Product Change Notice (PCN)

PCN Number: PCN-0451520R-01

Product(s) Affected: PJ-030DH-SMT-TR

Description of Change: mechanical, material, packaging, and soldering differences as shown below:

PREVIOUS CUI DEVICES DETAIL / IMAGE	NEW CUI DEVICES DETAIL / IMAGE

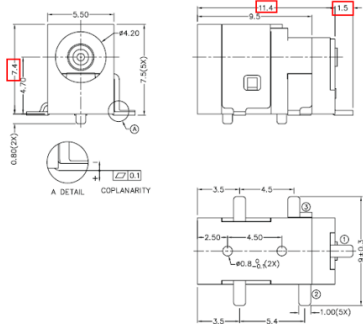
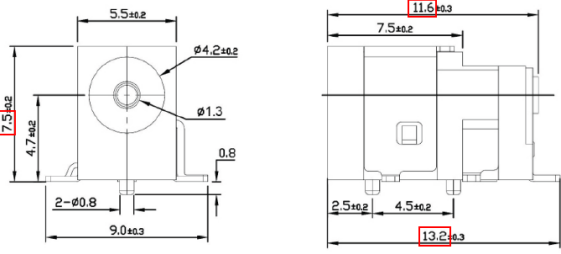
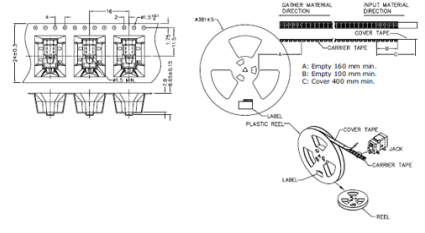
<p>Recommended PCB Layout Top View</p>	 <p>Recommended PCB Layout Top View</p>

<table border="1"> <thead> <tr> <th></th> <th>MATERIAL</th> <th>PLATING</th> </tr> </thead> <tbody> <tr> <td>center pin</td> <td>copper</td> <td>nickel</td> </tr> <tr> <td>terminal 1</td> <td>brass</td> <td>silver</td> </tr> <tr> <td>terminal 2</td> <td>copper alloy</td> <td>silver</td> </tr> <tr> <td>terminal 3</td> <td>brass</td> <td>silver</td> </tr> <tr> <td>shield</td> <td>cold rolled steel</td> <td>nickel</td> </tr> <tr> <td>plastic</td> <td>PA6T or equivalent</td> <td></td> </tr> </tbody> </table>		MATERIAL	PLATING	center pin	copper	nickel	terminal 1	brass	silver	terminal 2	copper alloy	silver	terminal 3	brass	silver	shield	cold rolled steel	nickel	plastic	PA6T or equivalent		<table border="1"> <thead> <tr> <th>DESCRIPTION</th> <th>MATERIAL</th> <th>PLATING/COLOR</th> </tr> </thead> <tbody> <tr> <td>center pin</td> <td>brass</td> <td>tin</td> </tr> <tr> <td>terminal 1</td> <td>brass t=0.3</td> <td>silver</td> </tr> <tr> <td>terminal 2</td> <td>phosphorus bronze t=0.3</td> <td>silver</td> </tr> <tr> <td>terminal 3</td> <td>brass t=0.4</td> <td>silver</td> </tr> <tr> <td>shield</td> <td>stainless steel</td> <td>nickel</td> </tr> <tr> <td>housing</td> <td>PPA (UL94V-0)</td> <td>black</td> </tr> </tbody> </table>	DESCRIPTION	MATERIAL	PLATING/COLOR	center pin	brass	tin	terminal 1	brass t=0.3	silver	terminal 2	phosphorus bronze t=0.3	silver	terminal 3	brass t=0.4	silver	shield	stainless steel	nickel	housing	PPA (UL94V-0)	black

MATERIAL	PLATING																																															
center pin	copper	nickel																																															
terminal 1	brass	silver																																															
terminal 2	copper alloy	silver																																															
terminal 3	brass	silver																																															
shield	cold rolled steel	nickel																																															
plastic	PA6T or equivalent																																																
DESCRIPTION	MATERIAL	PLATING/COLOR																																															
center pin	brass	tin																																															
terminal 1	brass t=0.3	silver																																															
terminal 2	phosphorus bronze t=0.3	silver																																															
terminal 3	brass t=0.4	silver																																															
shield	stainless steel	nickel

housing	PPA (UL94V-0)	black																																															
 <p>MATING PLUG Jack Insertion Depth: 6.6mm</p>	 <p>MATING PLUG Jack Insertion Depth: 6.5mm</p>																																																
<p>SOLDERABILITY</p> <table border="1"> <thead> <tr> <th>parameter</th> <th>conditions/description</th> <th>min</th> <th>typ</th> <th>max</th> <th>units</th> </tr> </thead> <tbody> <tr> <td>reel storage</td> <td>at relative humidity <80%</td> <td></td> <td></td> <td>40</td> <td>°C</td> </tr> <tr> <td>reflow soldering¹</td> <td>see reflow profile</td> <td>255</td> <td>260</td> <td>265</td> <td>°C</td> </tr> <tr> <td>drying conditions²</td> <td>parts in reel: bake at 40°C ±5°C for 72 hours parts removed from reel: bake at 40°C ±5°C for 10 hours</td> <td></td> <td></td> <td></td> <td></td> </tr> </tbody> </table> <p>Note: 1. Must reflow solder within 72 hours from opening vacuum packaging at a temperature <30°C & relative humidity <60%. 2. When exceeding floor life by >72 hours.</p> 	parameter	conditions/description	min	typ	max	units	reel storage	at relative humidity <80%			40	°C	reflow soldering ¹	see reflow profile	255	260	265	°C	drying conditions ²	parts in reel: bake at 40°C ±5°C for 72 hours parts removed from reel: bake at 40°C ±5°C for 10 hours					<p>SOLDERABILITY</p> <table border="1"> <thead> <tr> <th>parameter</th> <th>conditions/description</th> <th>min</th> <th>typ</th> <th>max</th> <th>units</th> </tr> </thead> <tbody> <tr> <td>reel storage</td> <td>10-30°C, <70% humidity</td> <td></td> <td></td> <td></td> <td>°C</td> </tr> <tr> <td>reflow soldering¹</td> <td>see reflow profile</td> <td>255</td> <td>260</td> <td></td> <td>°C</td> </tr> <tr> <td>drying conditions²</td> <td>parts in reel: bake at 110°C for 4 hours parts removed from reel: bake at 110°C for 4 hours</td> <td></td> <td></td> <td></td> <td></td> </tr> </tbody> </table> <p>Note: 1. CUDEVICES recommends to solder within 72 hours from opening vacuum packaging at a temperature <30°C & relative humidity <60%. 2. When exceeding floor life by >48 hours.</p> 	parameter	conditions/description	min	typ	max	units	reel storage	10-30°C, <70% humidity				°C	reflow soldering ¹	see reflow profile	255	260		°C	drying conditions ²	parts in reel: bake at 110°C for 4 hours parts removed from reel: bake at 110°C for 4 hours

parameter	conditions/description	min	typ	max	units																																												
reel storage	at relative humidity <80%			40	°C																																												
reflow soldering ¹	see reflow profile	255	260	265	°C																																												
drying conditions ²	parts in reel: bake at 40°C ±5°C for 72 hours parts removed from reel: bake at 40°C ±5°C for 10 hours																																																
parameter	conditions/description	min	typ	max	units																																												
reel storage	10-30°C, <70% humidity				°C																																												
reflow soldering ¹	see reflow profile	255	260		°C																																												
drying conditions ²	parts in reel: bake at 110°C for 4 hours parts removed from reel: bake at 110°C for 4 hours																																																
<p>Reel Size: 0321 mm Reel QTY: 600 pcs per reel</p>  <p> A: Empty 16.0 mm min. B: Empty 10.0 mm min. C: Cover 4.0 mm min. </p>
